604123-111717

ADDENDUM NO. 5

**Federal Aid Project Nos. CMQ-003S(390), STP-003S(390) & TAP-003S(390)
Roadway Reconstruction and Related Work along Route 126 (Pond Street)**

Transmitting revisions to the Contract Documents as follows:

STATE	FED. AID PROJ. NO.	SHEET NO.	TOTAL SHEETS
MA	CMO/TAP/ISTP-003S(390)	191	331
PROJECT FILE NO.		604123

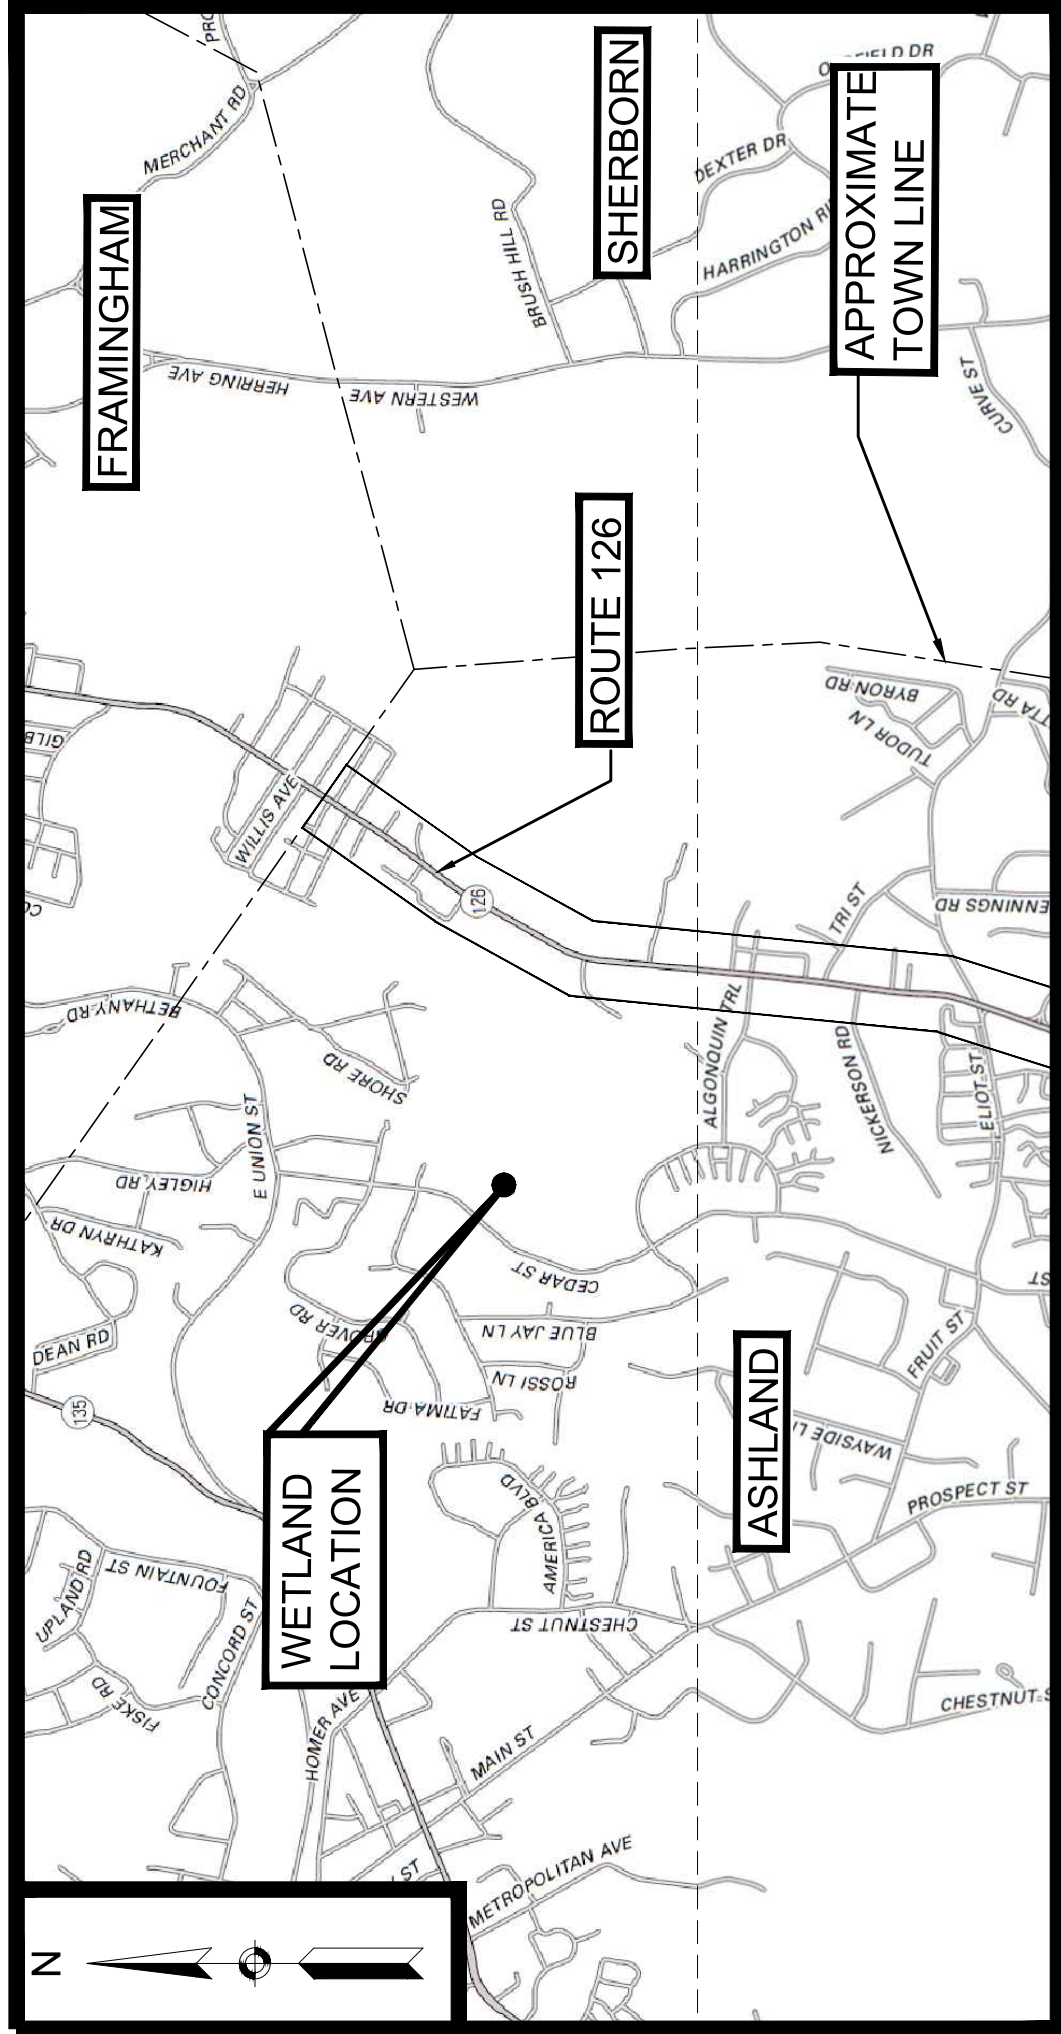
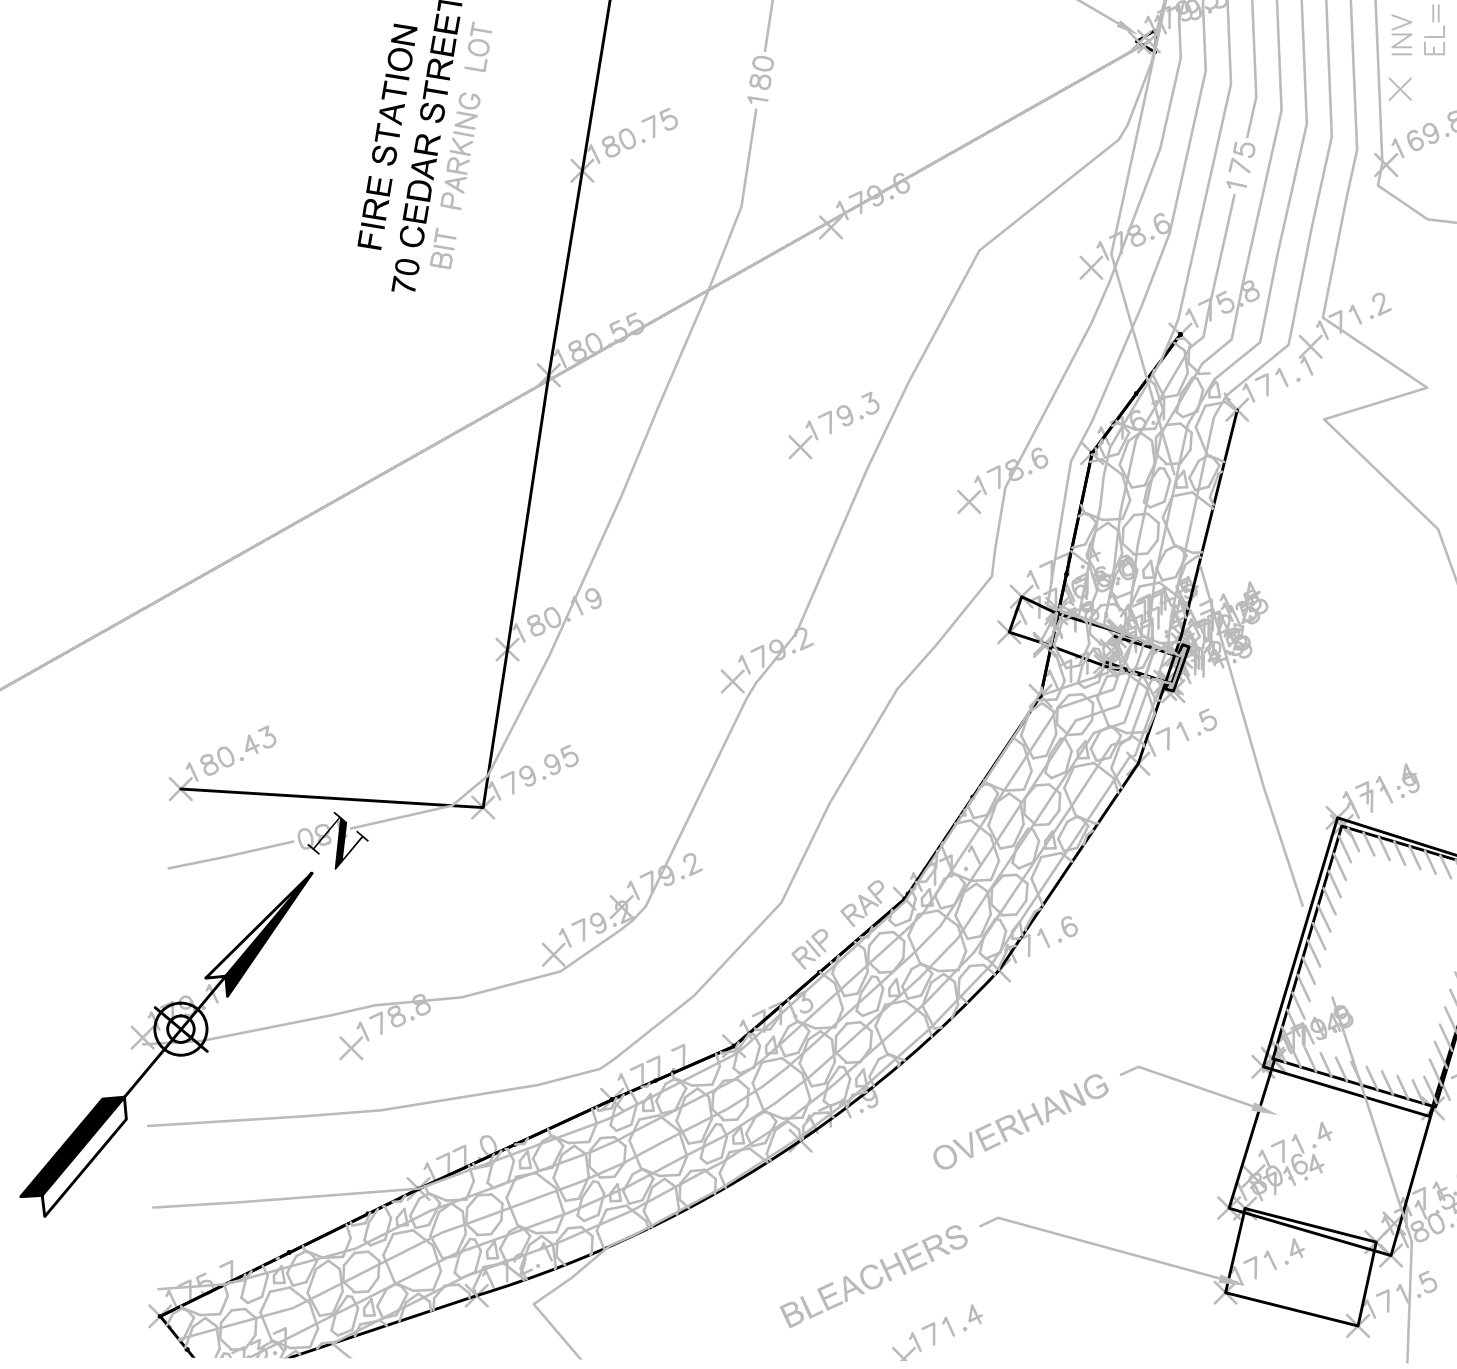
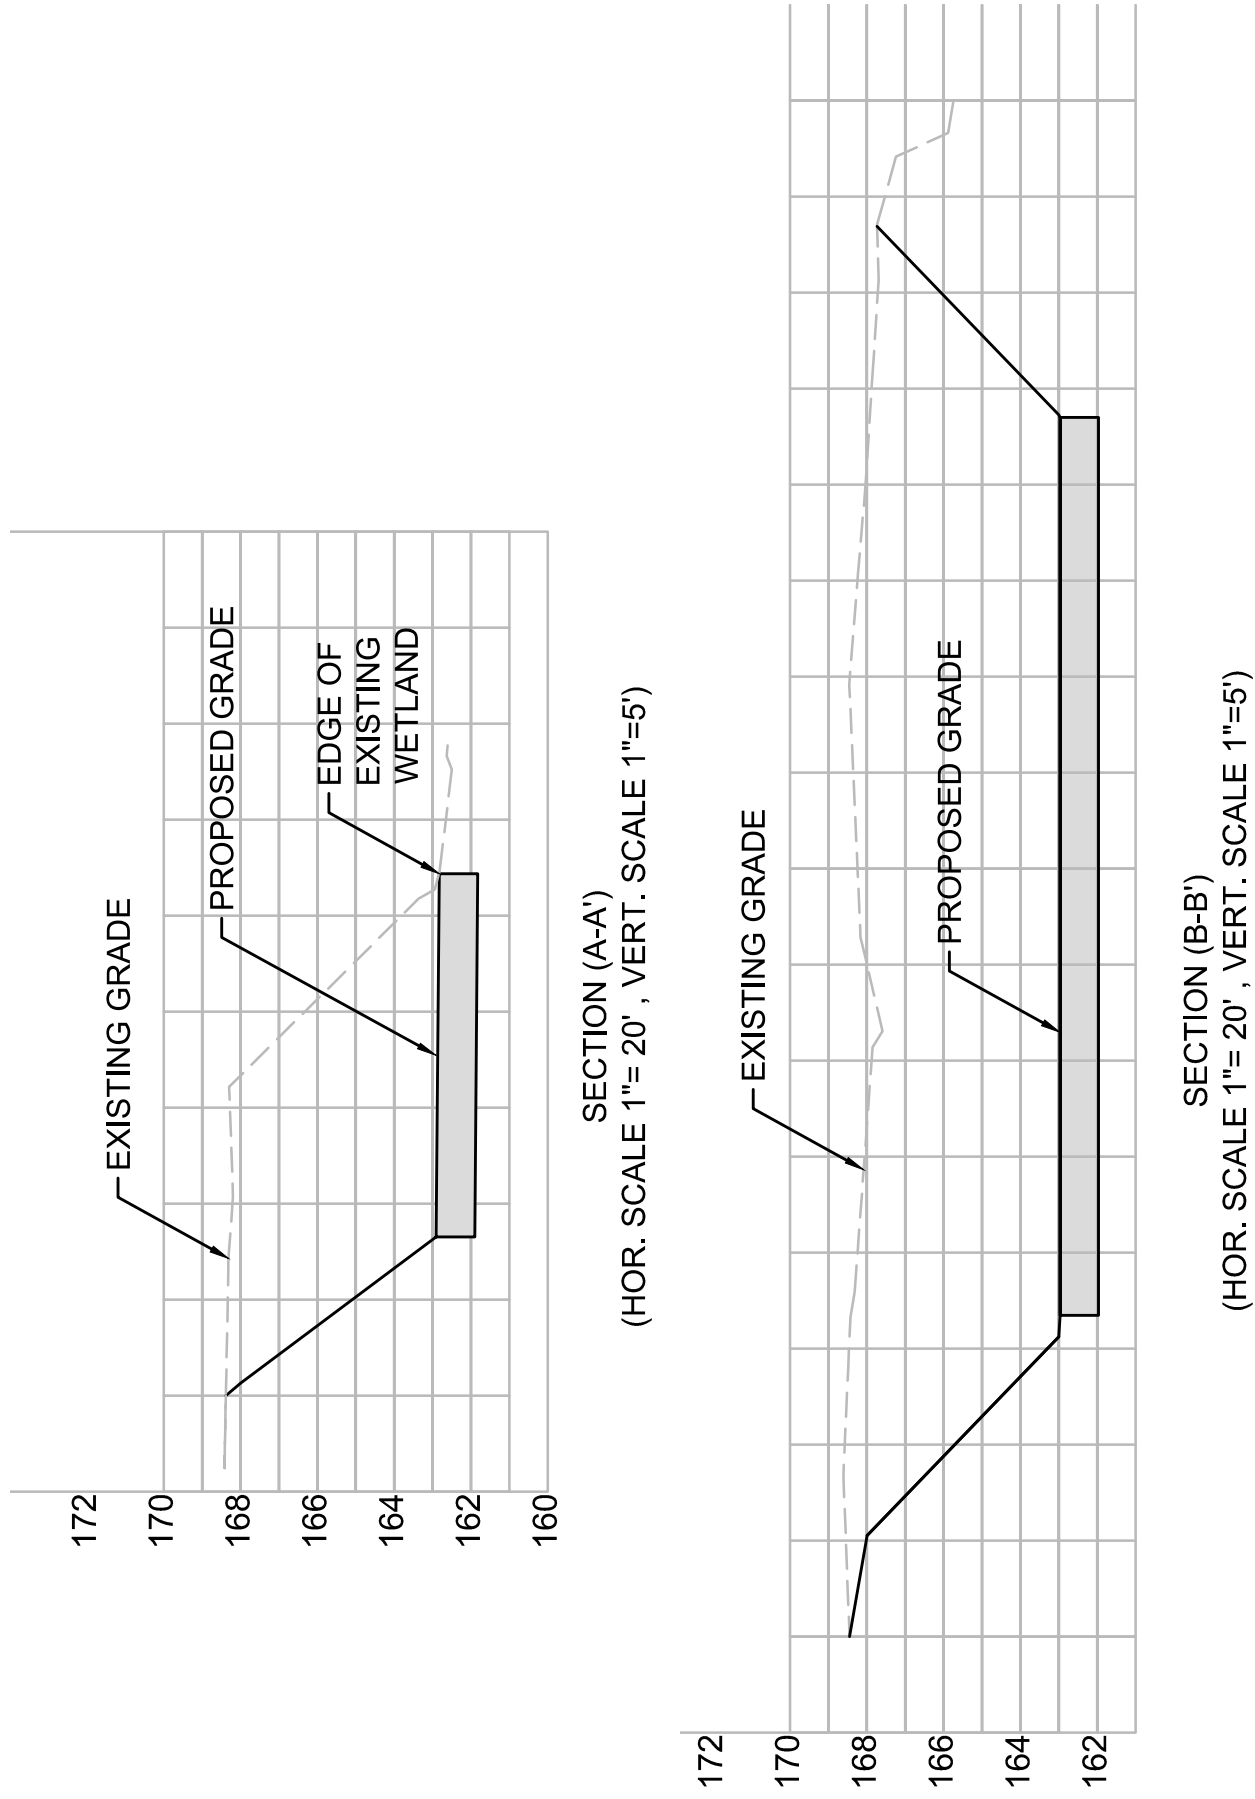
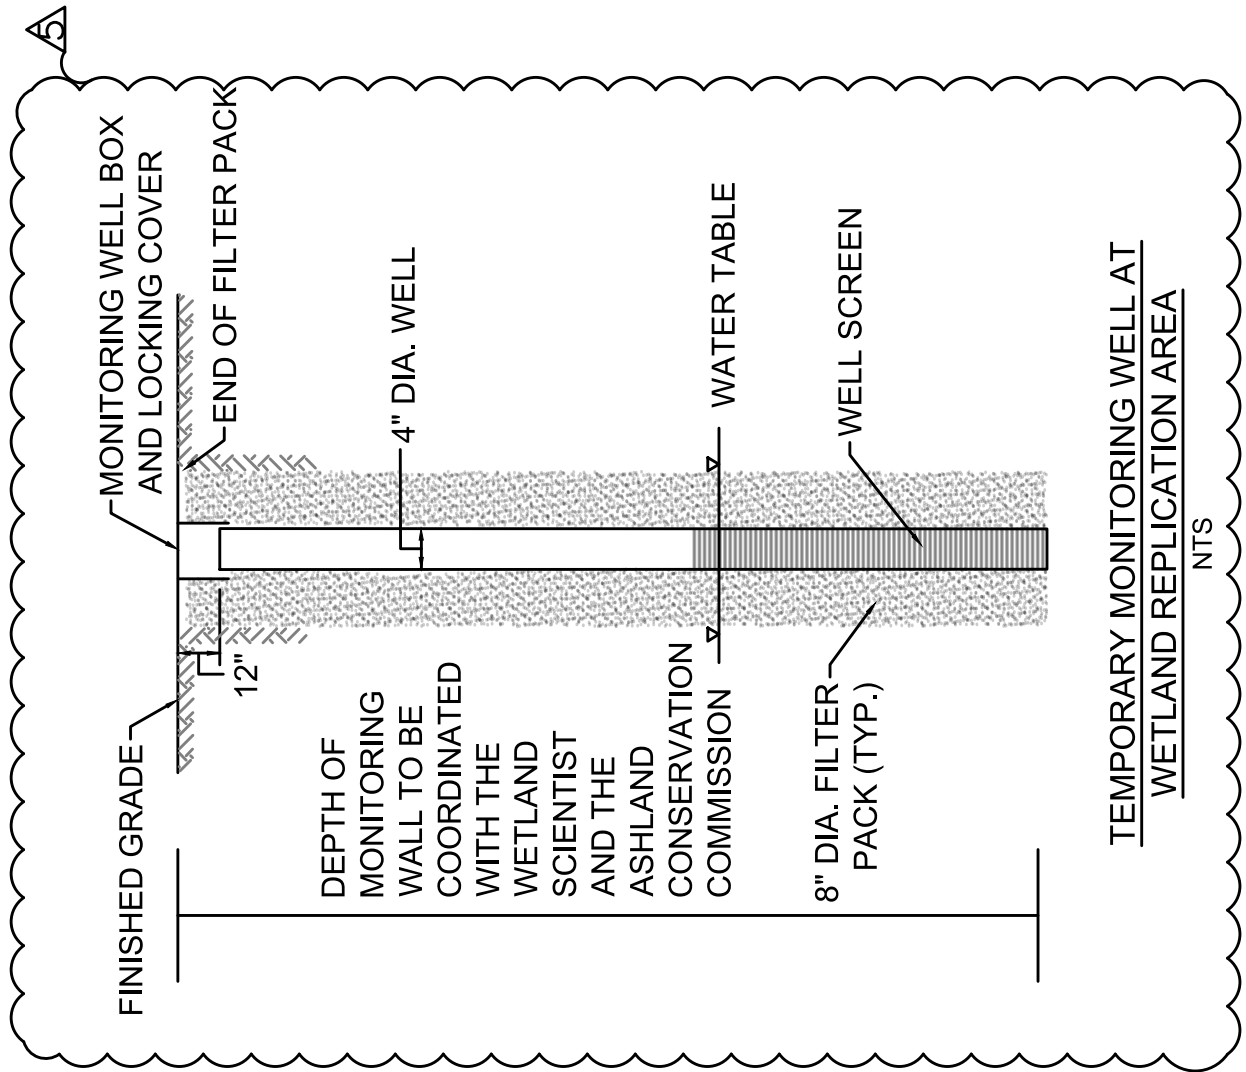
Question #55: The Special Provisions for Item 755.35 state that monitoring wells shall include data loggers.

Please provide a detail of the monitoring well

Please provide information regarding the data loggers such as acceptable brands and model numbers.

Response #55: See revised Sheet 191 of 331. The Contractor shall submit data logger shop drawings to the Wetland Specialist for approval.
